# Potential Mohave Ground Squirrel Impacts Solar Millennium Ridgecrest Solar Power Project

Dave Hacker, Staff Environmental Scientist  
California Department of Fish and Game  
May 4, 2010

**09-AFC-9**

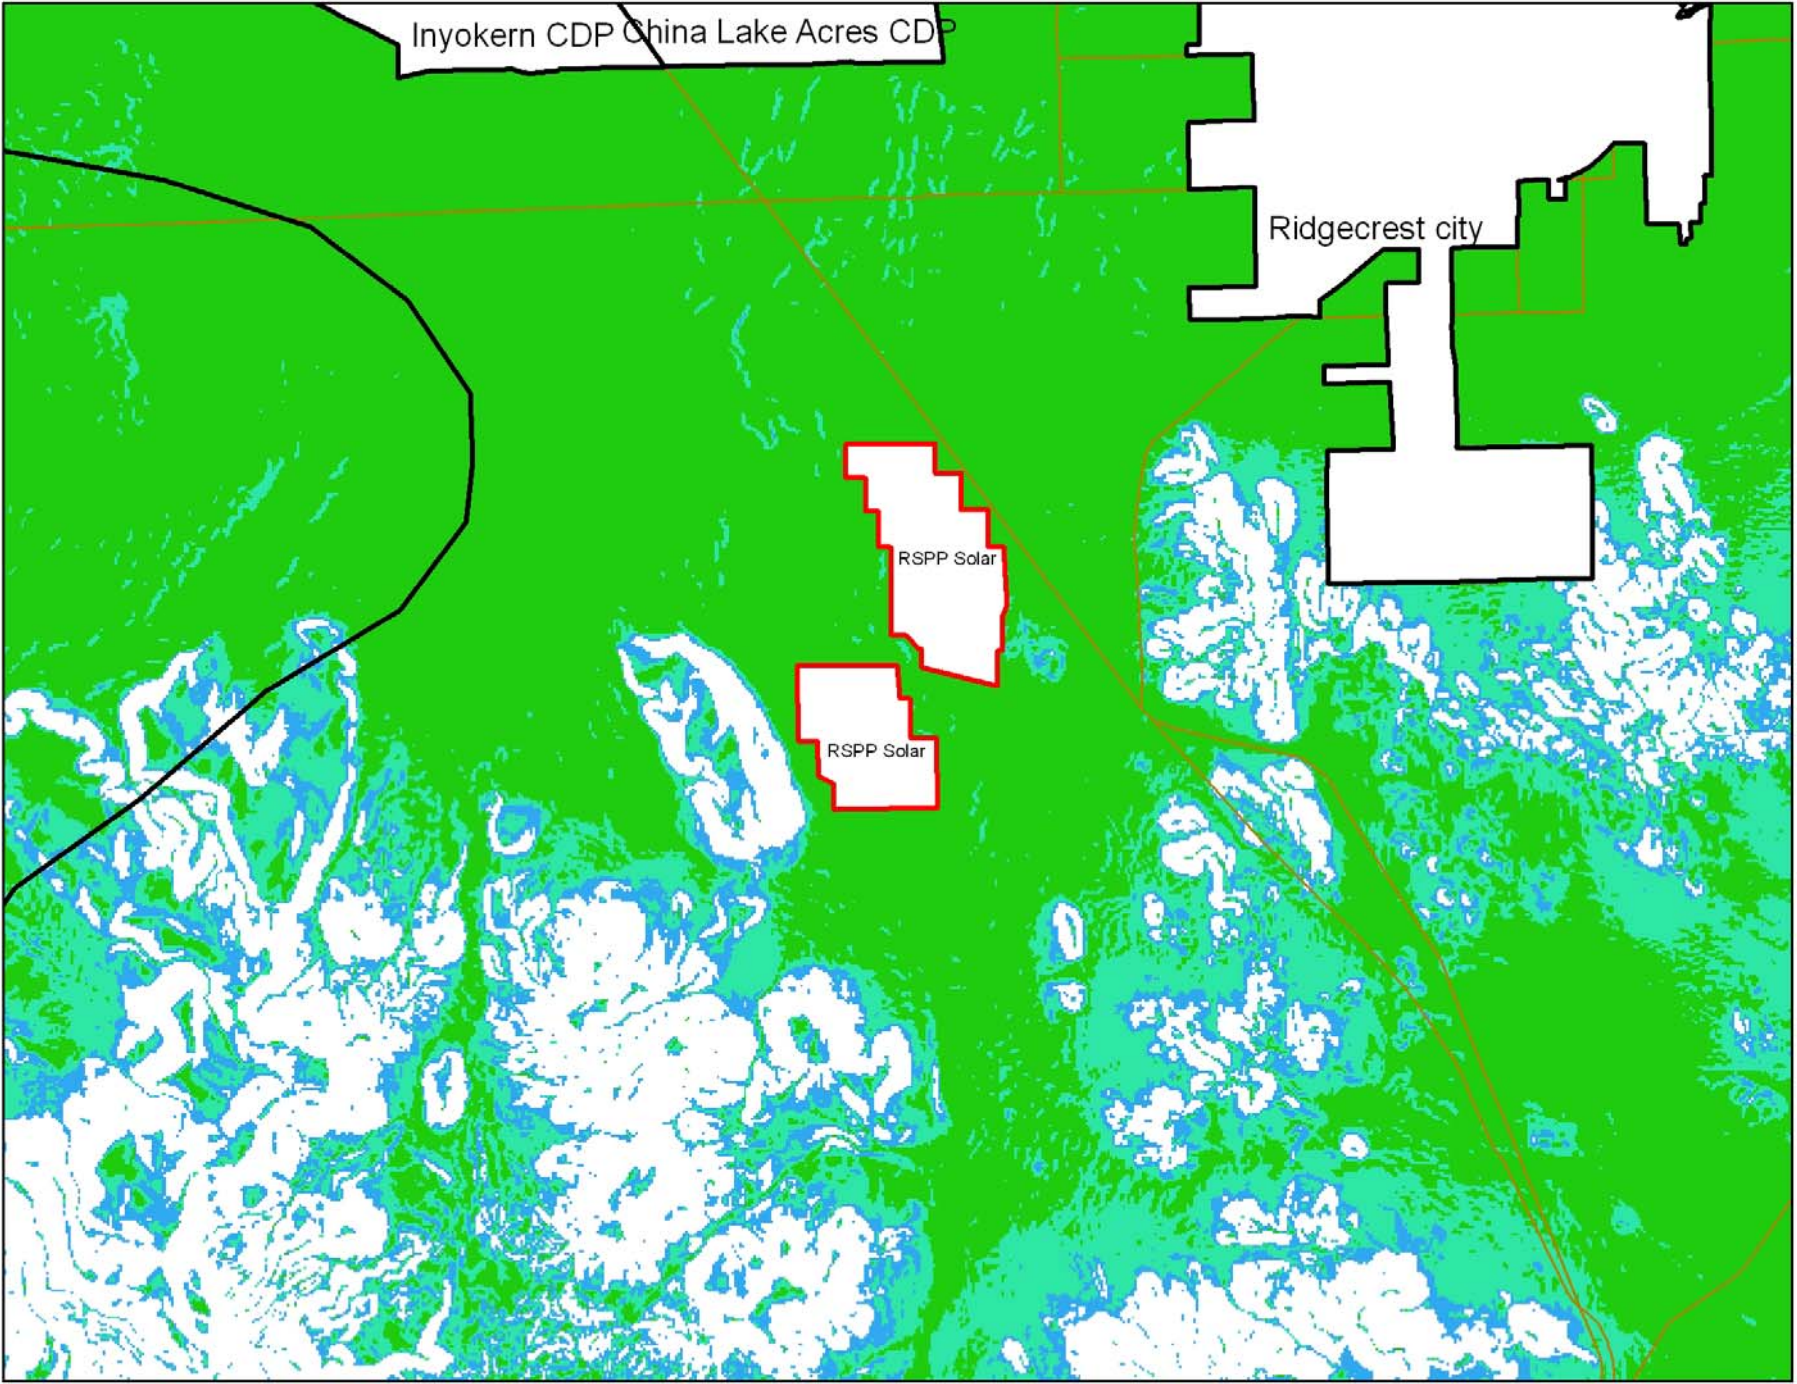
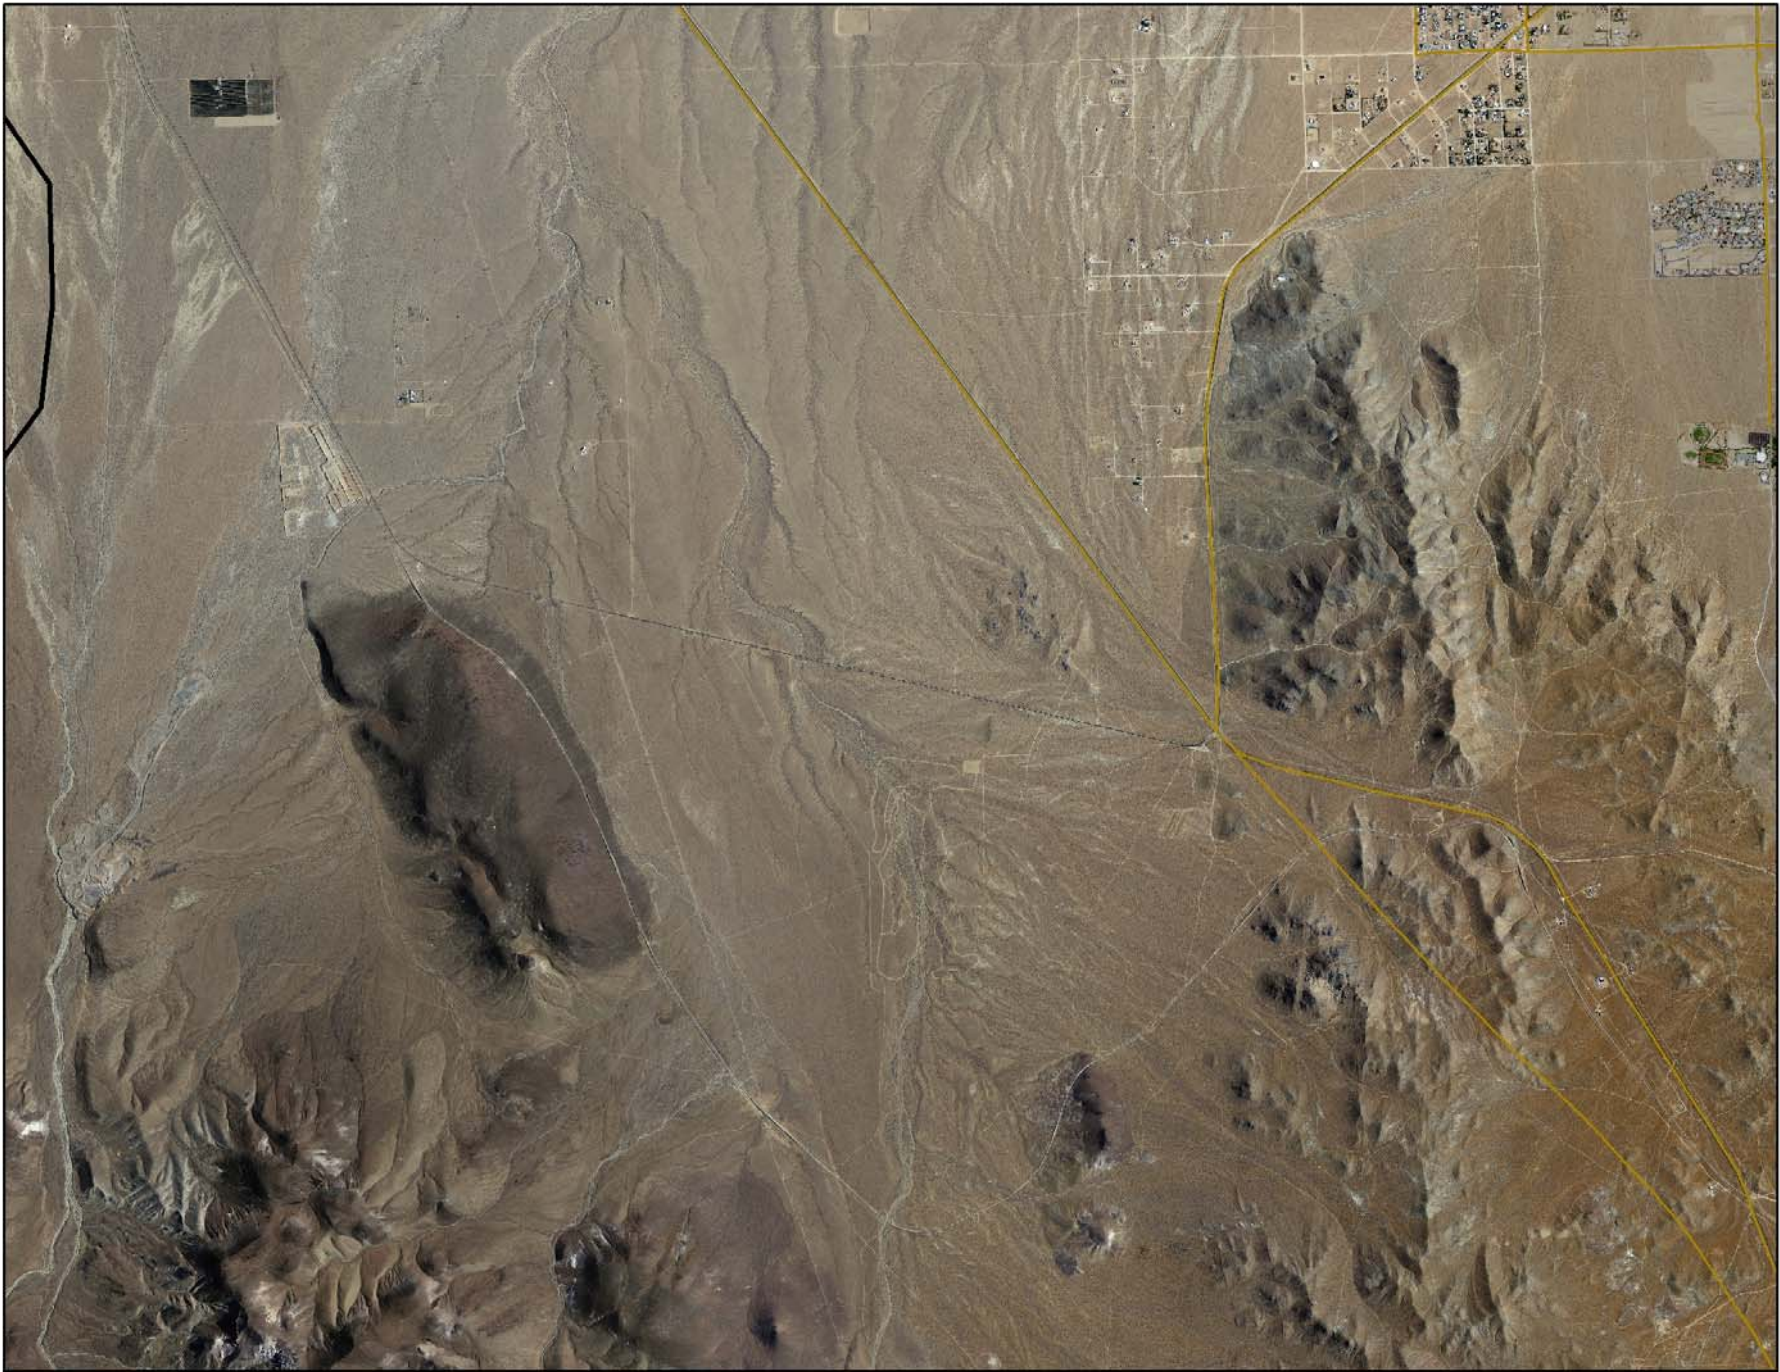
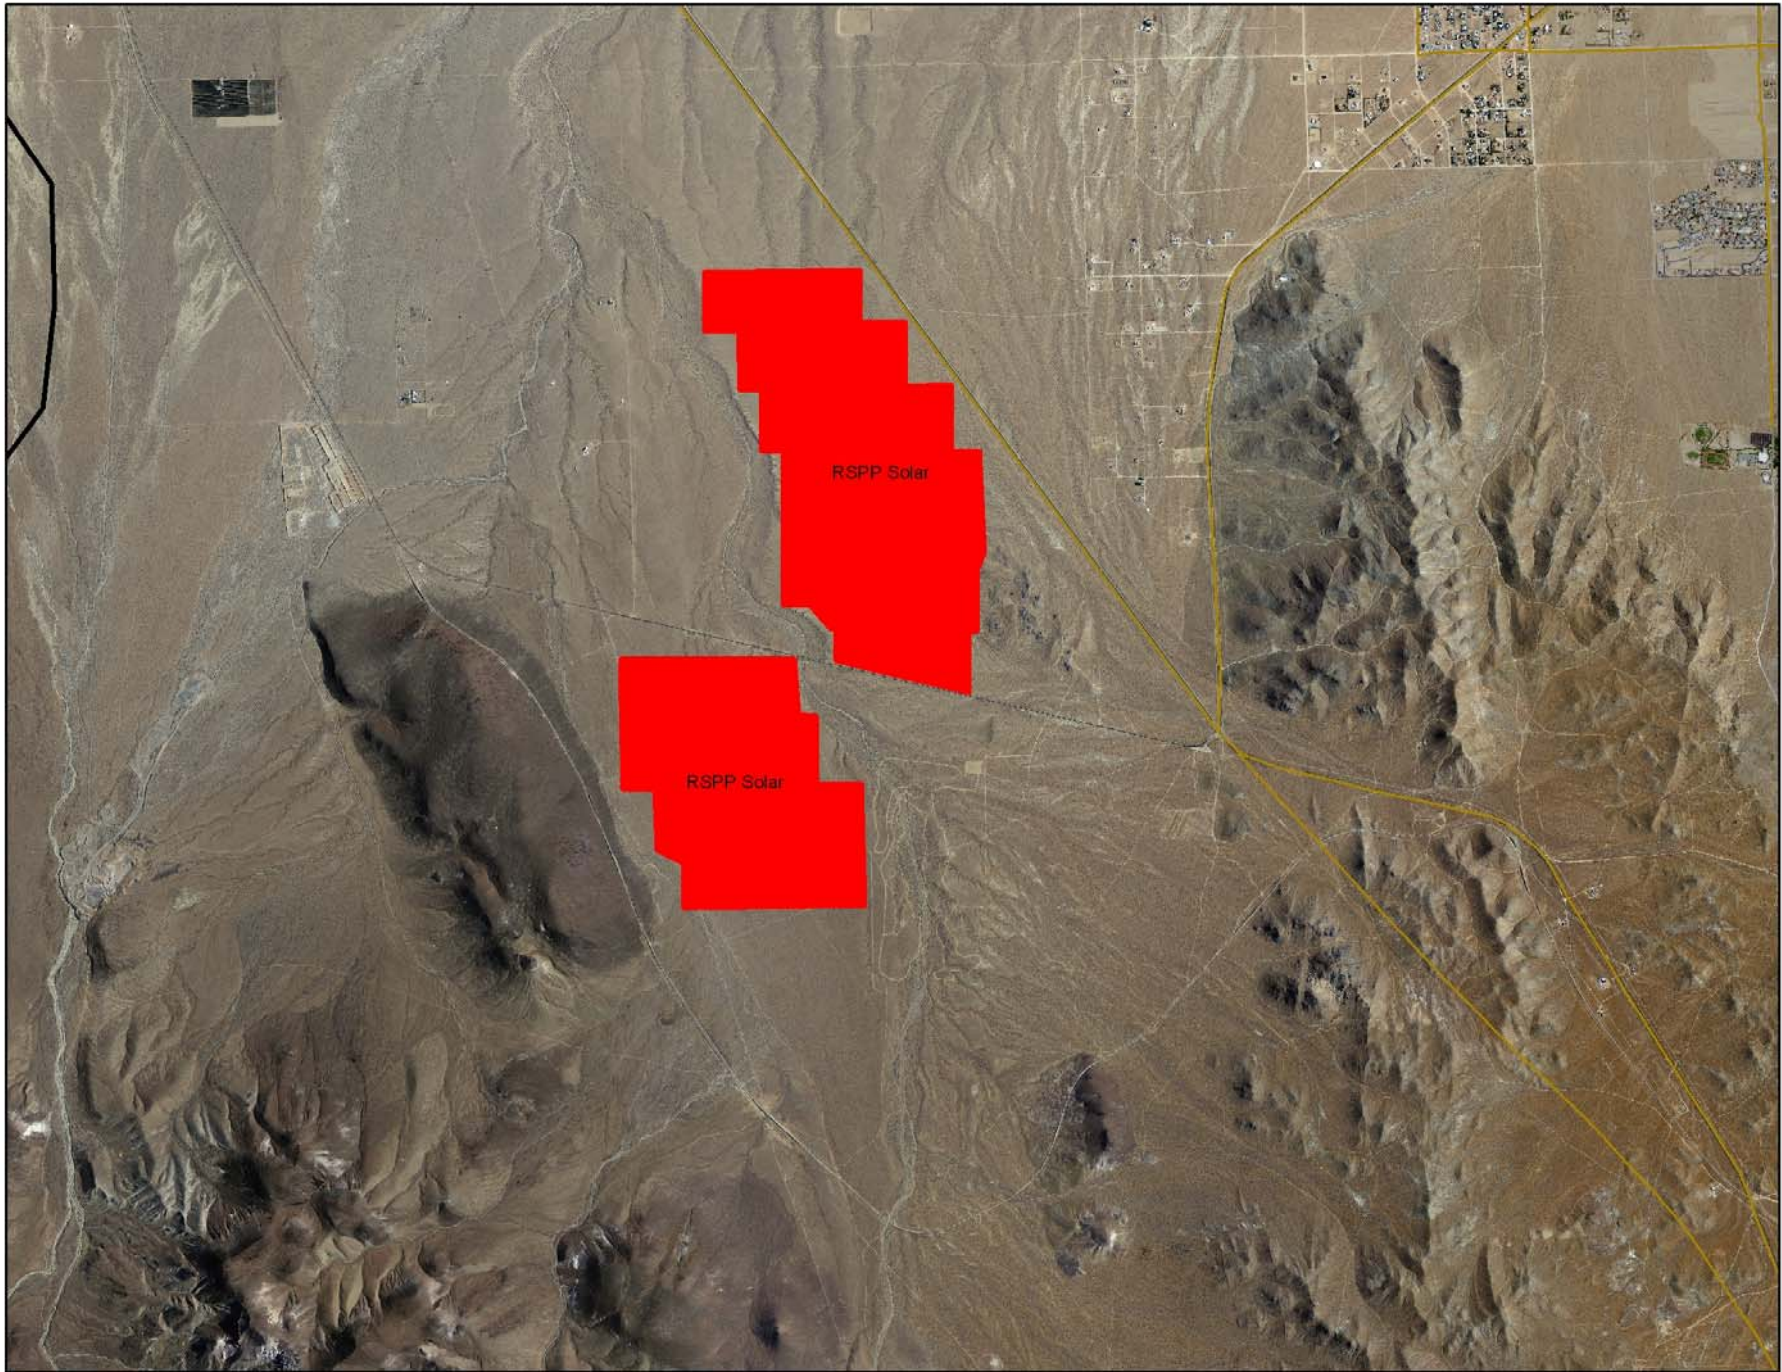
# CESA Requires Full Mitigation

- How can we replace the connectivity function that this site provides?
- Leitner (2008) ID's this specific area to connect Little Dixie Wash to other populations.
- That recommendation was based in sound, widely-accepted conservation biological principles.
